**Olive Branch Community Church, Preliminary Plan, 120110410**

**Preliminary Plan No. 120110410: Olive Branch Community Church**

*Staff Recommendation: Approval with Conditions*

*Preliminary Plan*

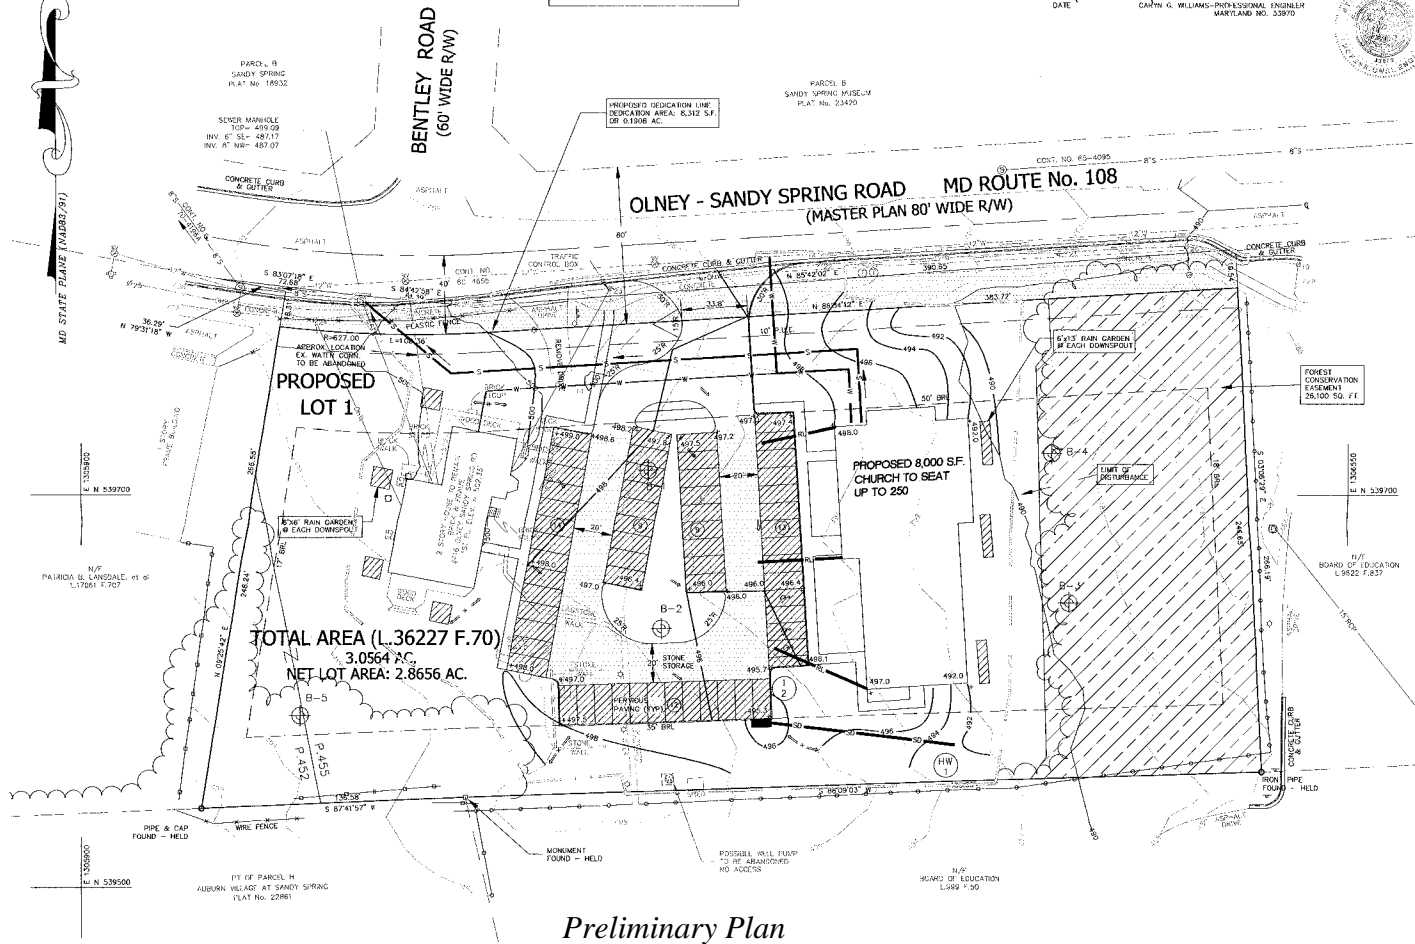
3. The Applicant must dedicate, and the record plat must reflect, the master-planned recommended 80-foot right-of-way (40 feet from centerline to match the existing right-of-way dedication from existing properties) for Olney-Sandy Spring Road as shown on the preliminary plan.

The ROW will be widened by 40 feet with the proposed dedication of 8,312 square feet. As indicated on the Preliminary Plan, the total ROW shall be a maximum of 80 feet wide.

Access to the proposed church site will be via a driveway along Olney – Sandy Spring Road (MD 108). This driveway will be a single entrance to the site, combining the existing two driveways. Staff finds that the proposed access points and internal traffic/pedestrian circulation system as shown on the Preliminary Plan are adequate.

**PRELIMINARY FOREST CONSERVATION PLAN**

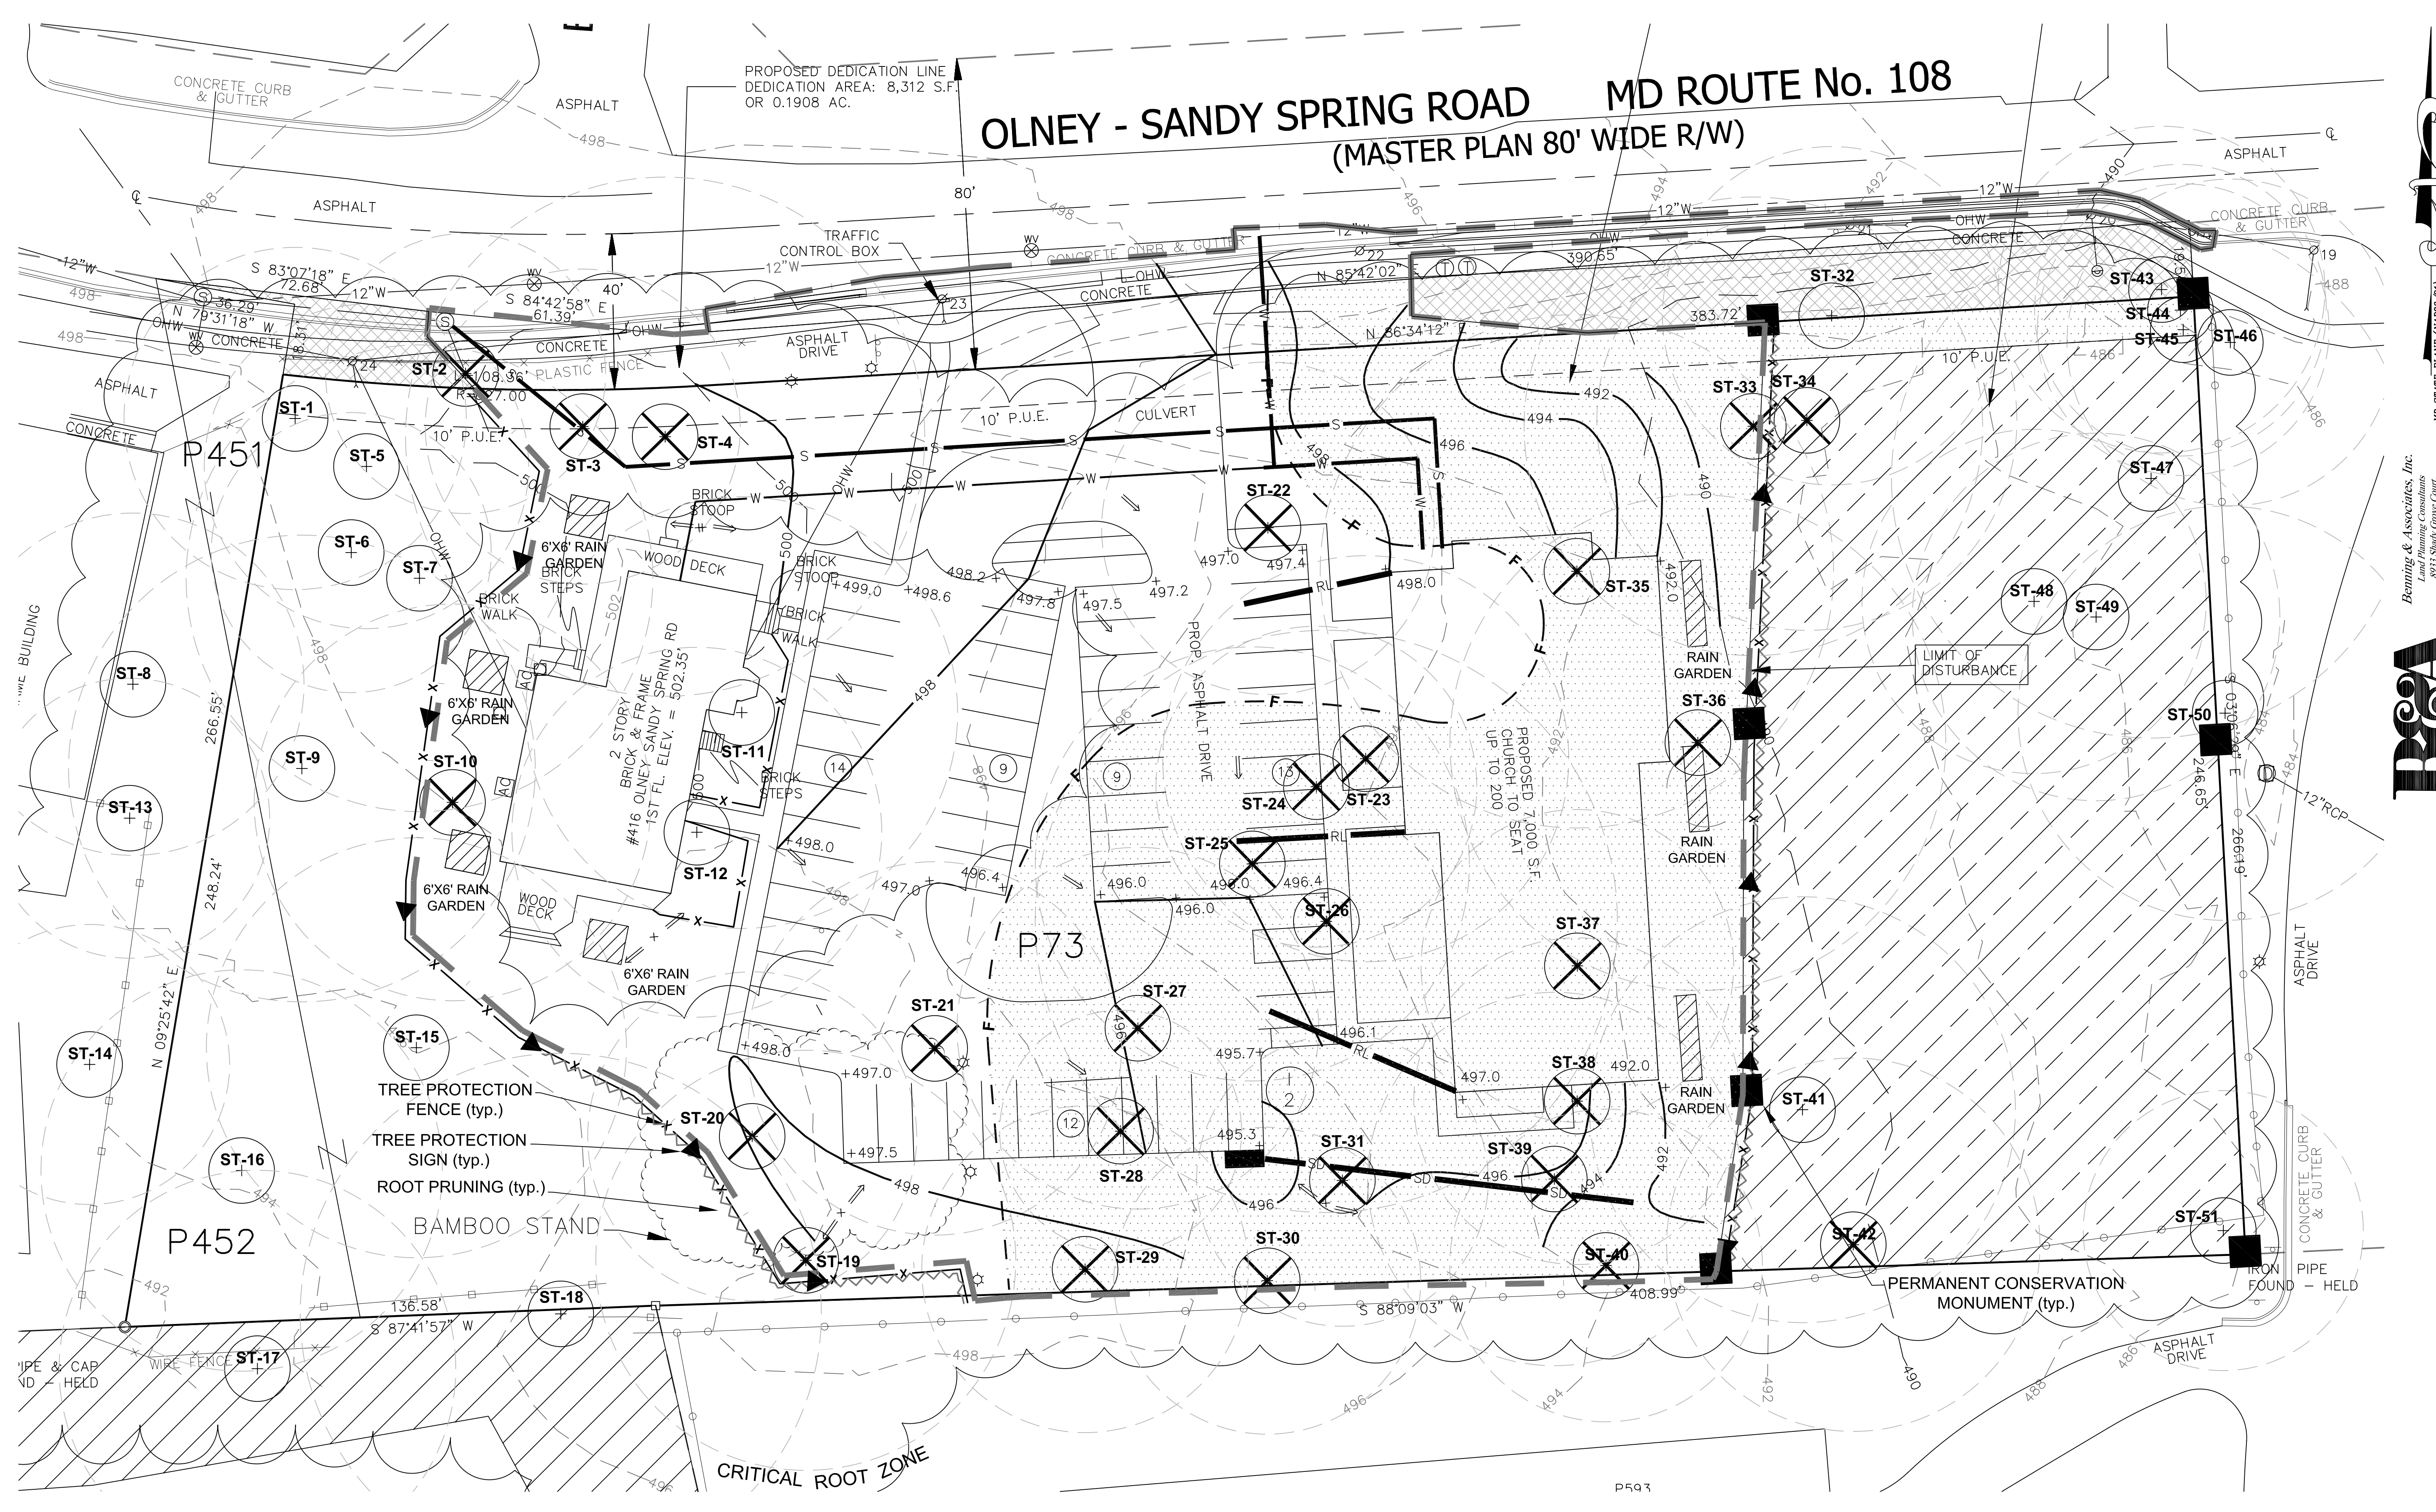
- a. Approval of Final Forest Conservation Plan consistent with the approved Preliminary Forest Conservation Plan prior to any clearing, grading or demolition on the site.

- b. Mitigation for the loss of sixteen specimen trees to be provided by planting, forty-nine, 3-inch caliper native canopy trees on site. The proposed mitigation must be included on the Final Forest Conservation Plan.

- c. Final Sediment Control Plan must be consistent with the final limit of disturbance as approved by M-NCPPC staff.
    - d. All retained forest shall be protected in a Category I conservation easement. Conservation easements must be shown on record plats.

**Variance Request** - The applicant submitted a variance request on October 5, 2011 for the impacts/removal of trees with the proposed layout (Attachment B). The applicant proposes to remove sixteen (16) trees that are 30 inches and greater, DBH, and to impact, but not remove, five (5) others that are considered high priority for retention under Section 22A-12(b) (3) of the County Forest Conservation Law.

Variance Recommendation - Staff recommends that the variance be granted with mitigation provided for the loss of trees.
